RE: Pre-application Review for **Category B Driveway**, Pre-application Meeting Date: **January 27, 2022**

Broward County - Lauderdale Lakes; SR 7; Sec. # 86100000; MP: 14.30; Access Class - 5;

Request: Use existing joint use, right-in/right-out driveway on the east side of SR 7 approximately 185 feet south of NW 44th Street.

Project Name & Address: **Lauderdale Lakes Self-Storage – SEC SR 7 and NW 44th Street, Lauderdale Lakes, FL**
Property Owner: **ARJ Properties, Inc.**; Parcel Size: **2.80 Acres** Development Size: **99,450 SF Self-Storage**

| SHEET: EX-4 | | |

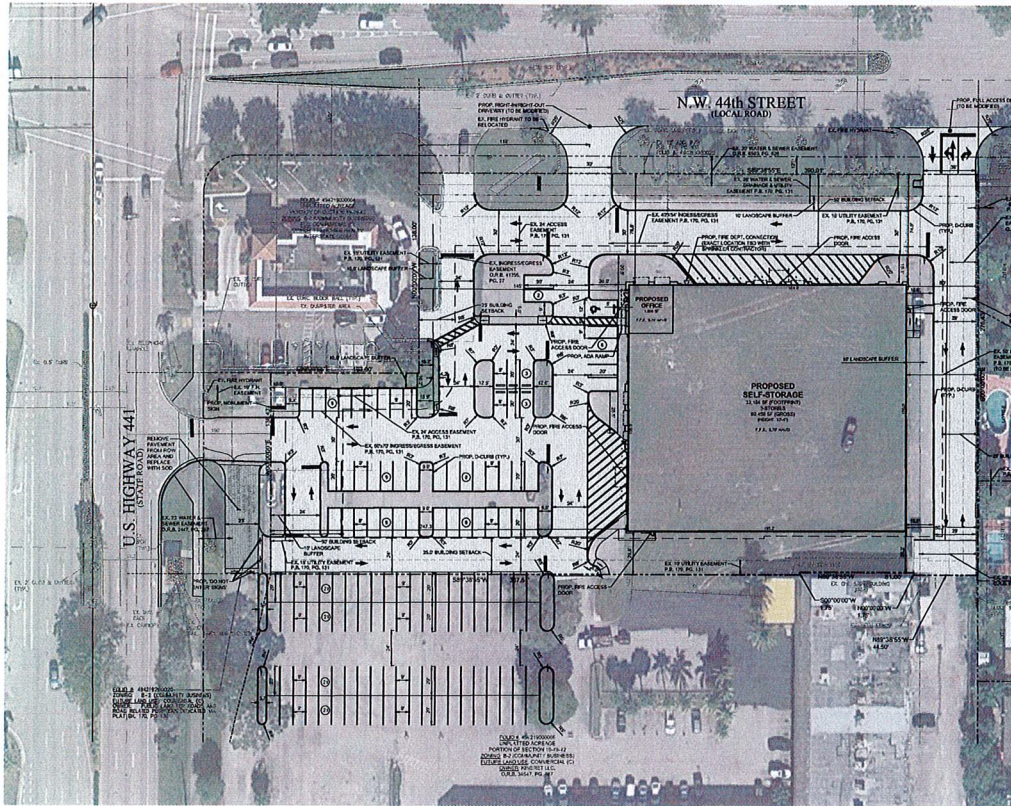
- A minimum driveway length of 10 feet on the inbound side and 20 feet on the outbound side, as measured from the ultimate right-of-way line to the first conflict point shall be provided.
- If a gate is proposed, a minimum driveway length of 100 feet and a turnaround area before the gate are required.
- The existing cross access with the site adjacent to the south shall be maintained.
- The existing paved drive aisle within FDOT right-of-way shall be relocated to be within private property, as per the attached concept plan.
- All site plan features such as drive aisles and parking spaces shall be within private property and outside of FDOT right-of-way.

- All driveways not approved in this letter must be fully removed and the area restored.
- A Drainage Permit is required for any stormwater impacts within FDOT right-of-way (i.e. increased runoff or reduction of existing storage).
- The applicant shall donate property to the Department if right-of-way dedication is required to implement the improvements.
- Dimensions between driveways are measured from the near edge of pavement to near edge of pavement and for median openings are measured from centerline to centerline unless otherwise indicated.
